APPROVED MEETING MINUTES

Seattle Opera

This was the Seattle Design Commission's (SDC) first review of the proposed concept design. Following the presentation, SDC review and deliberation, the SDC voted, 8-0, in favor of the concept design, with several conditions and recommendations.

Concept Design

Figure 3: Proposed facade treatment

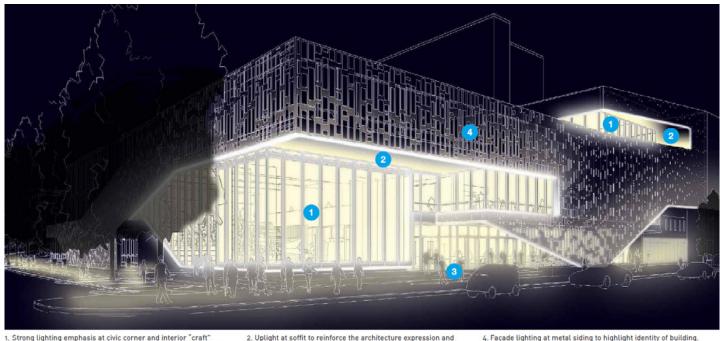
The SDC appreciated the design team's attempt to use building design to reveal public performance spaces along Mercer St. and 4th Ave. N for pedestrians. The Commission is concerned with the overall placement and features of the scrim. Commissioners feel the scrim's size, location and treatment limit the transparency along important areas of the building façade, including the retail and opera box office from Mercer St. They recommended the design team rethink where, if at all, the scrim must touch the ground plane in order to create as much transparency as possible along the street level.

- 1. Continue thinking about the long- term potential for enhancing pedestrian experience along the project site edges as well as throughout Seattle Center
- 2. Consider how the design of the scrim negatively affect the facility's relationship with the pedestrian realm, specifically as it hits the ground plane along Mercer St, and McCaw Hall
- 3. Provide a strategy for engaging with an artist prior to schematic design review
- 4. Expand opportunities to view and interact with programming along 4th Ave. N, including the costume shop and rehearsal space.
